**ADDENDUM NO. 2  
10/28/22**

**SPECIFICATION NO. 22-11418-C**

**CITY OF BERKELEY**

**OHLONE PARK (EAST) PLAYGROUND REPLACEMENTS AND SITE IMPROVEMENTS**

PLAN 8261  
FILE 406-219  
**C-3.0**  
SHEET 5 OF 40

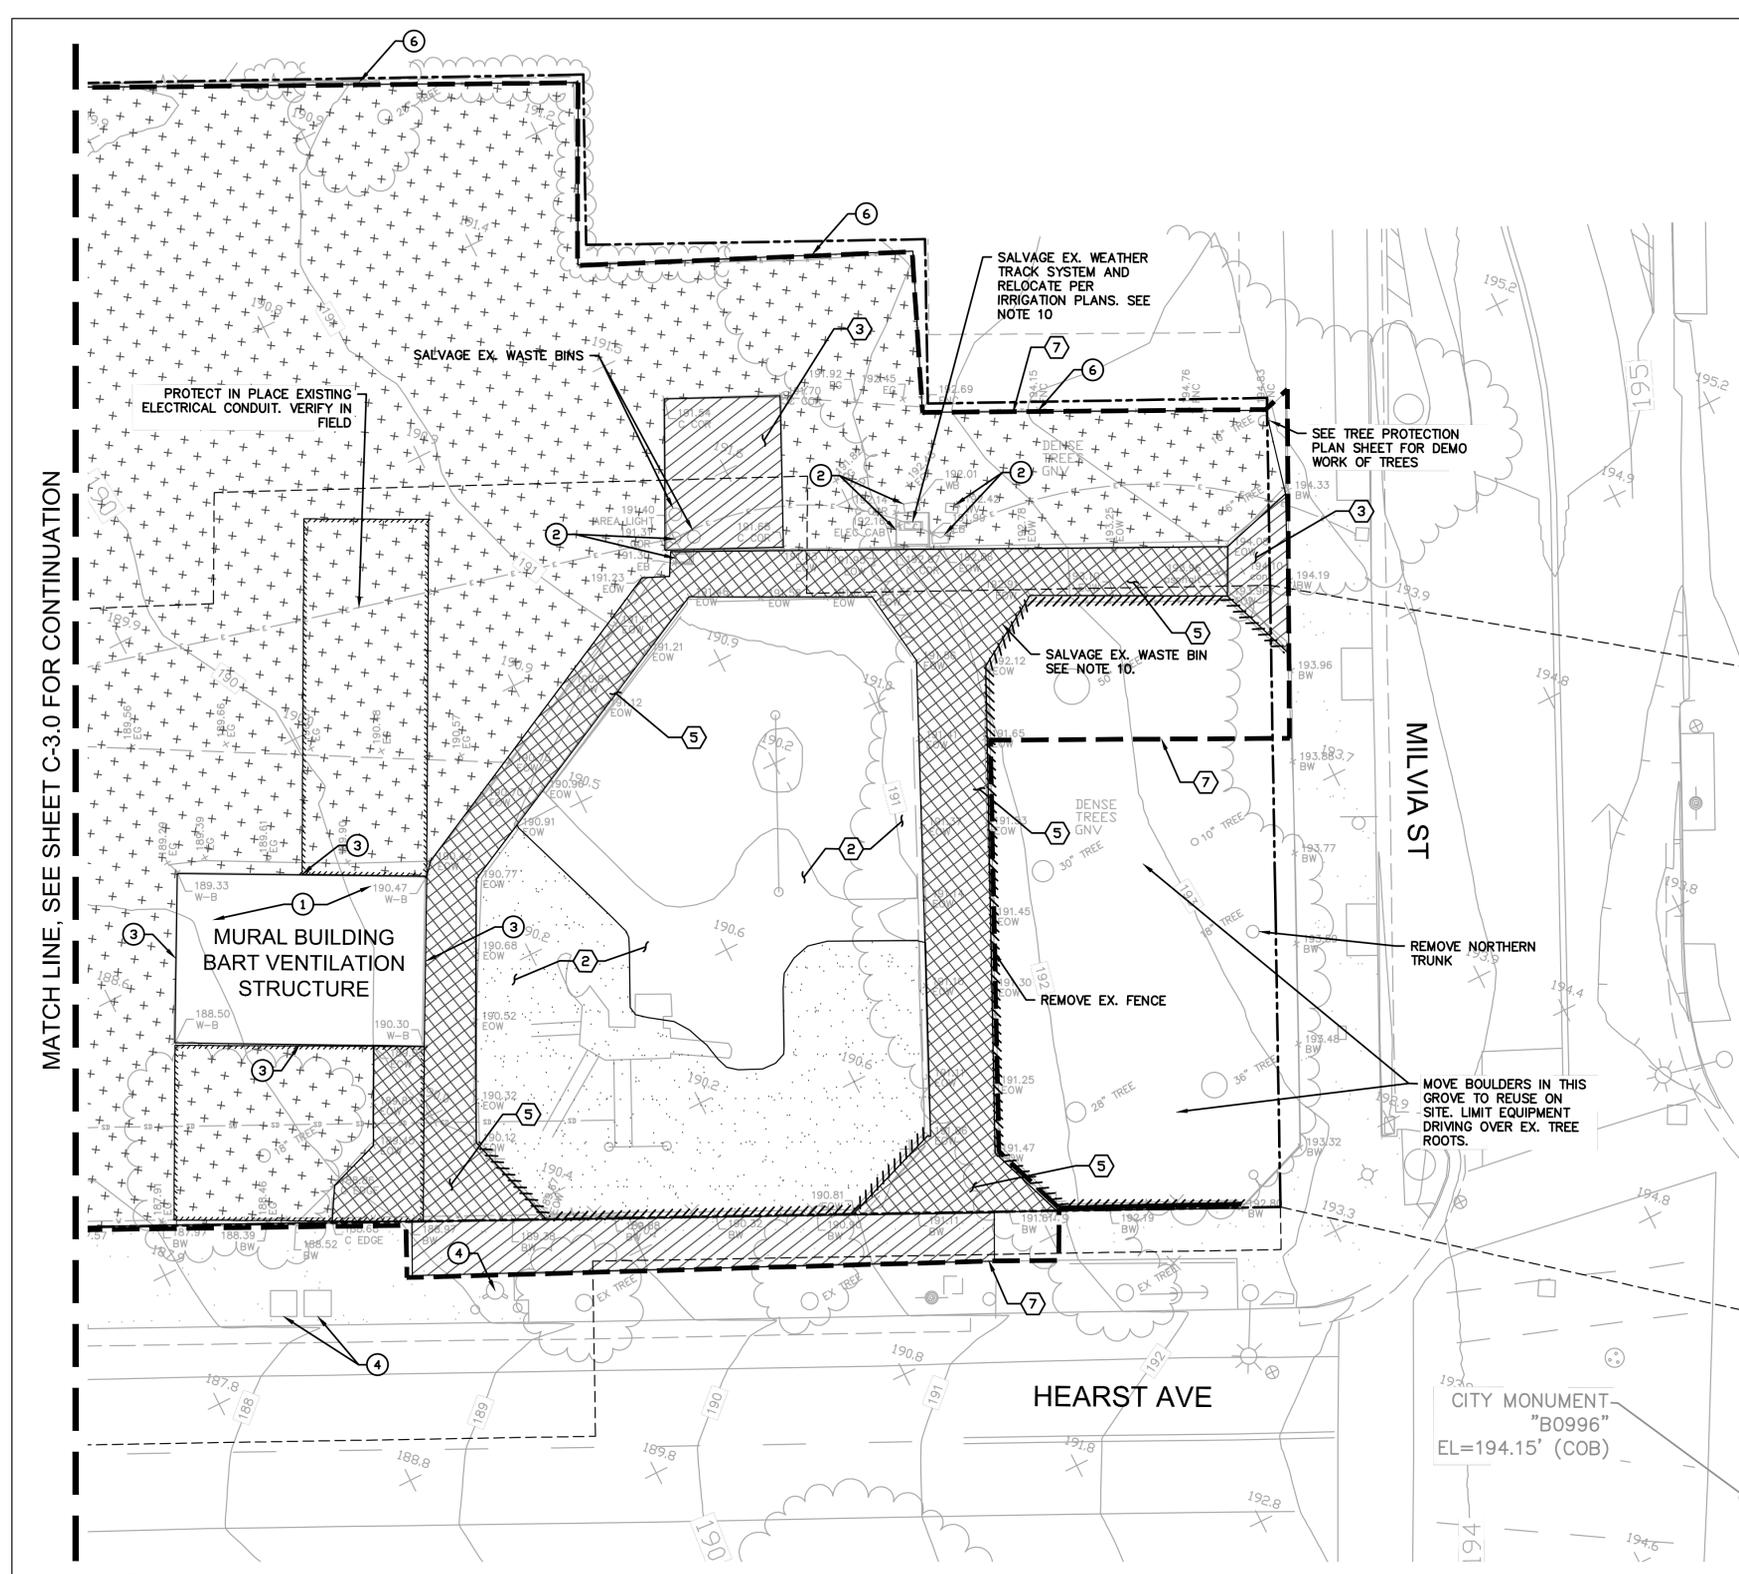
1. Replace the following sheets with updated sheets:
  - a. Sheet T-1.0 dated 10/28/22 – Added Alternate 3.
  - b. Sheets C-3.0 and C-3.1 dated 10/28/22 – Revised demolition items 8 and 9.

6. On sheet C-3.0, demolition item numbers 8 and 9 note to salvage existing bench and drinking fountain. Please provide the location of where salvaged items can be stored.

Response        Existing bench and drinking fountain shall be demolished. Please see revised sheet C-3.0. Other salvaged items shall be stored at a location to be determined and coordinated with the Owner’s representative.

PLAN 8261  
FILE 406-219  
**C-6.0**  
SHEET 10 OF 40

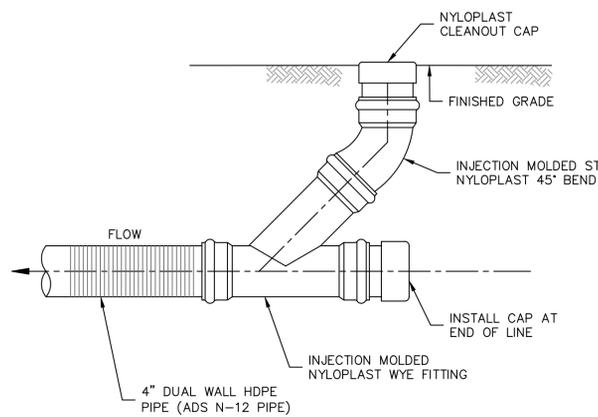
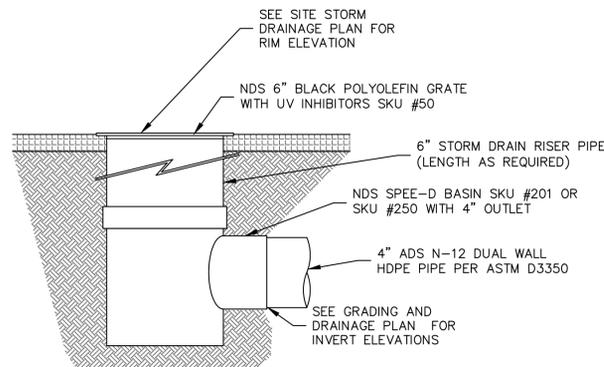
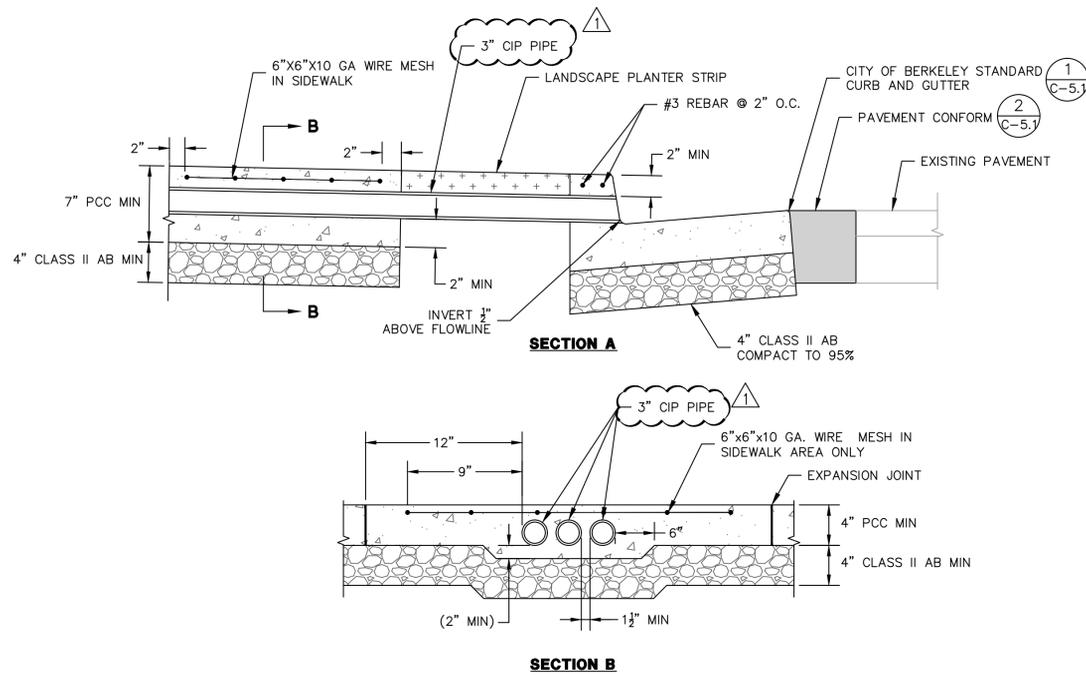
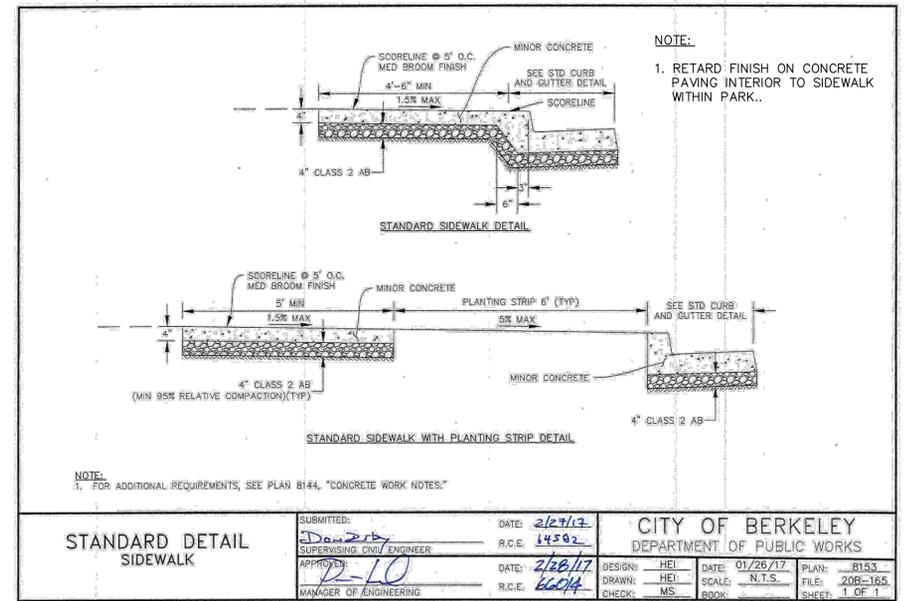
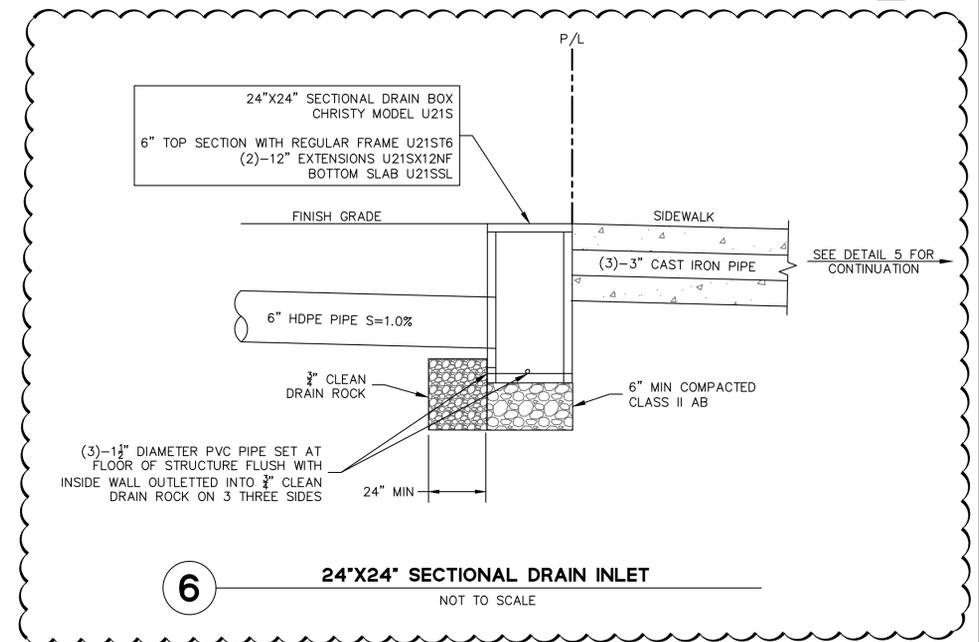
- c. Sheet C-5.0 dated 10/28/22 – Revised sidewalk drain with 24'x24' sectional drain box.
  - d. Sheet C-6.0 dated 10/28/22 – Revised sidewalk underdrain detail and inserted 24'x24' sectional drain inlet detail.

PLAN 8261  
FILE 406-219  
L-20  
SHEET 18 OF 40

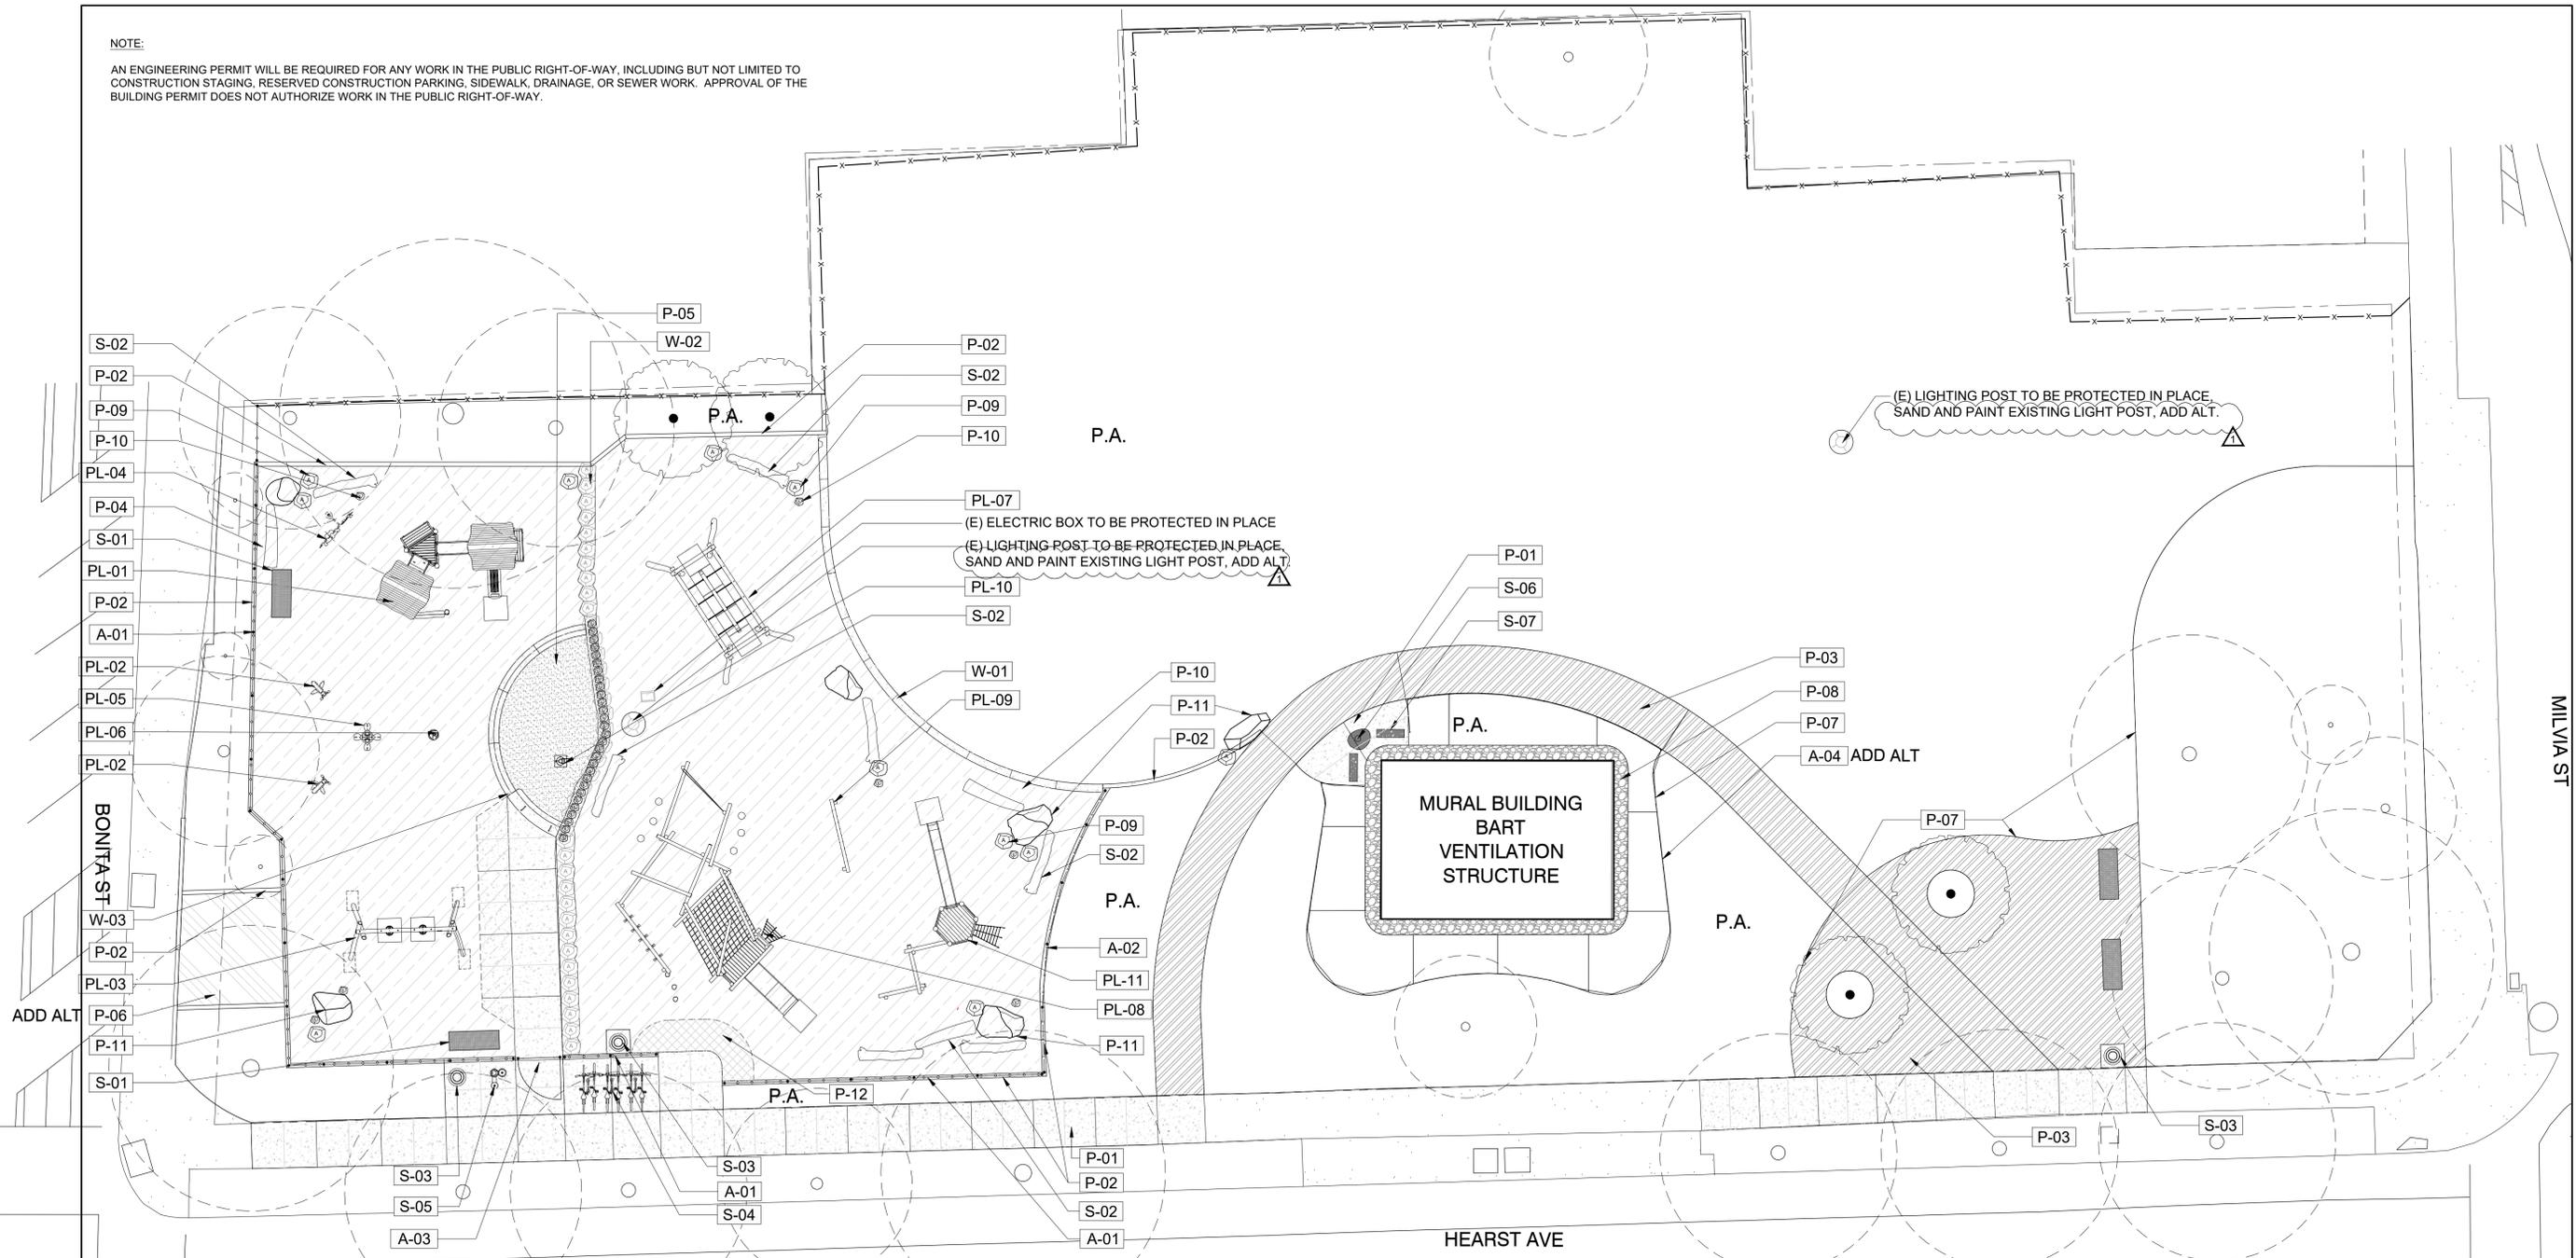
14. Refer to schedule of materials and site furnishings on sheet L-2.0, the quantities of boulder A, boulder B and salvaged boulders are supposed to be 11 EA, 7 EA, 6 EA and quantity of boulder wall supposed to be 76 LF with (29) head size boulders at top and (39) 2'x2' boulders. Please revise the quantity.

15. Refer to schedule of materials and site furnishings on sheet L-2.0, American Soil and Stone is the only specified supplier. Are approved equal material from other suppliers acceptable?

16. Refer to item P-01 and P-02 of schedule of materials and site furnishings on sheet L-2.0, it does appear that section 03 3001 is missing. Please provide.

Response Quantity for salvaged boulders is 8. Demolition sheet has been revised to remove the boulder symbol causing confusion. Contractor can also verify this quantity in the field. Quantities associated with proposed items have been revised on the Landscape Materials Schedule.

Response Approved equal material from other suppliers is acceptable. See revised sheet L-2.0. Per Document 00 2113 (Instructions to Bidders) paragraph 6.07 Substitutions, Bidders must base their Bids on products and systems specified in Contract Documents or listed by name in Addenda. City will consider substitution requests only for "or equal items." Bidders wanting to use "or equal" item(s) may submit Document 00 6325 (Substitution Request Form) no later than 35 Days after Notice of Award.

Response Section 03 3001 listed on sheet L-2.0 was a typo and should be section 03 3000. Revised plan sheet has been issued with this Addendum.

**07 BOULDER WALL**  
1" = 1'-0"

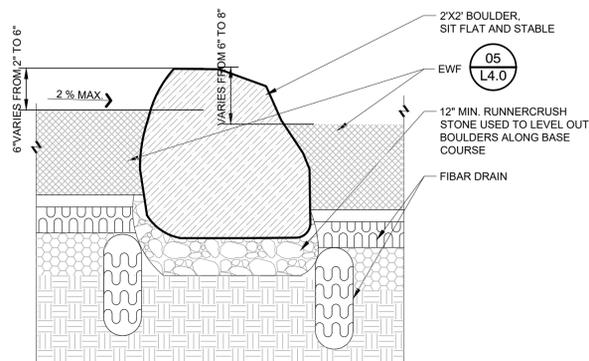
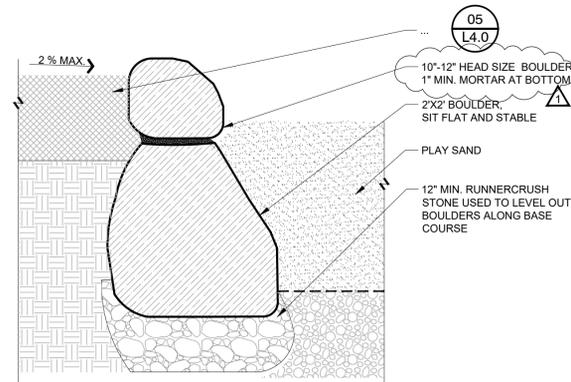
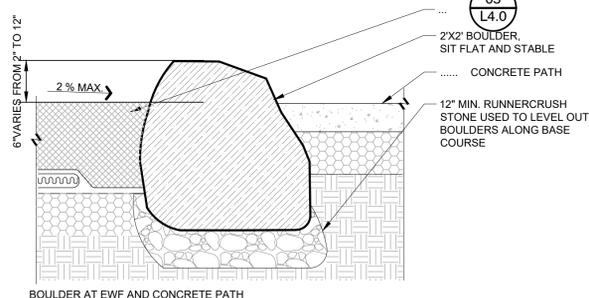
19. Please provide the dimensions required for the head size boulder referenced in detail 7 on sheet L-4.0.

Response Dimension has been added to detail 7 on sheet L-4.0. The dimension could also be found in the material schedule on sheet L-2.0.

**05 ENGINEERED WOOD FIBER (EWF)**  
NTS

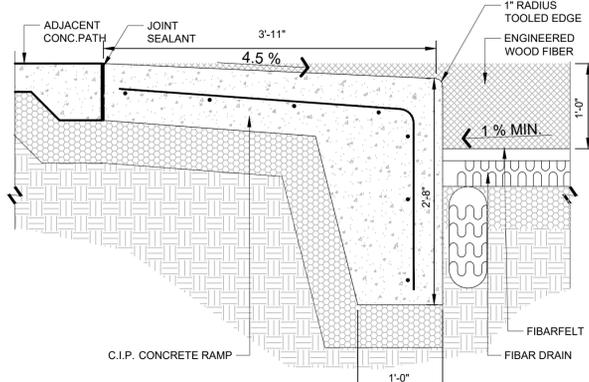
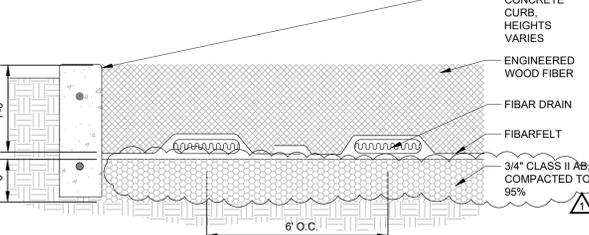
17. Refer to sheet L-2.1, there is an area where the hatch for engineered wood fiber is overlapping the hatch of concrete paving. Please clarify.

21. Refer to section 32 1816, part 3.05B, "aggregate subbase shall be fully compacted in 2" watered lifts to 95 percent". However, detail 5 on sheet L4.0 does not show aggregate subbase. Please confirm if aggregate subbase is required under redwood fiber playground surface. Also, provide a specification for aggregate subbase.

Response Refer to referenced detail for engineered wood fiber detail 05/L-4.0. "Condition at C.I.P. concrete ramp at 2-5 yrs play area" details this condition.

Response Confirmed, 6-inches of aggregate subbase has been added to detail 5/L-4.0.

**04 GRANITECRETE PAVING**  
1 1/2" = 1'-0"

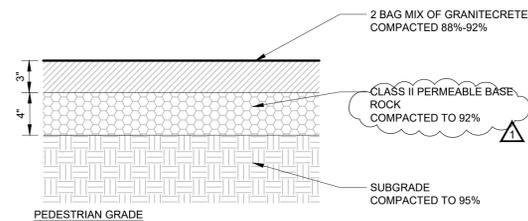
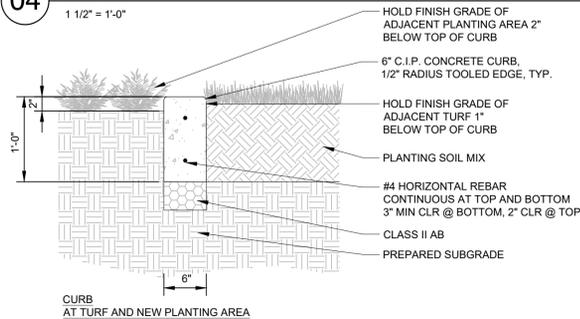
20. Detail 4 on sheet L-4.0 shows Class II Aggregate Base to be installed under Granitecrete. However, section 32 1541, part 2.03 shows that base course material rock to be Class II Permeable Base Rock. Please clarify.

Response Detail 7/L-4.0 has been updated to match section 32 1541, part 2.03.

**01 CHAINLINK FENCE 42" TALL**  
1" 1'-0" P

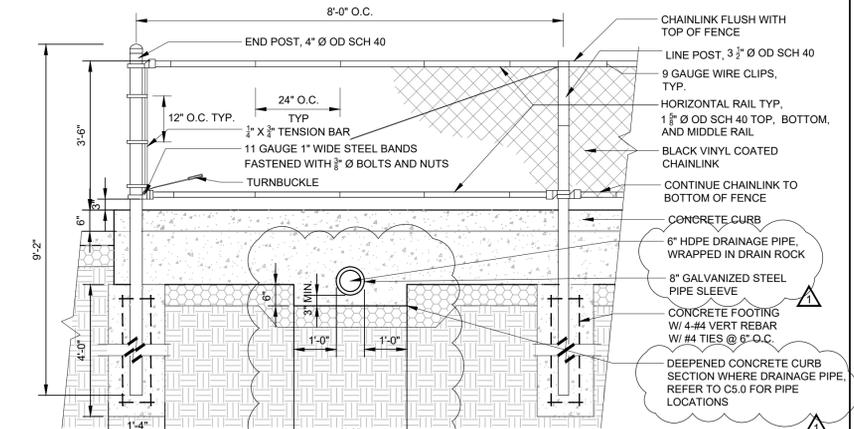
- g. Sheet L-4.0 dated 10/28/22 – Revisions to details 3, 4, 5, and 7.
  - h. Sheet L-4.2 dated 10/28/22 – Revisions to chainlink fence 42" tall detail.
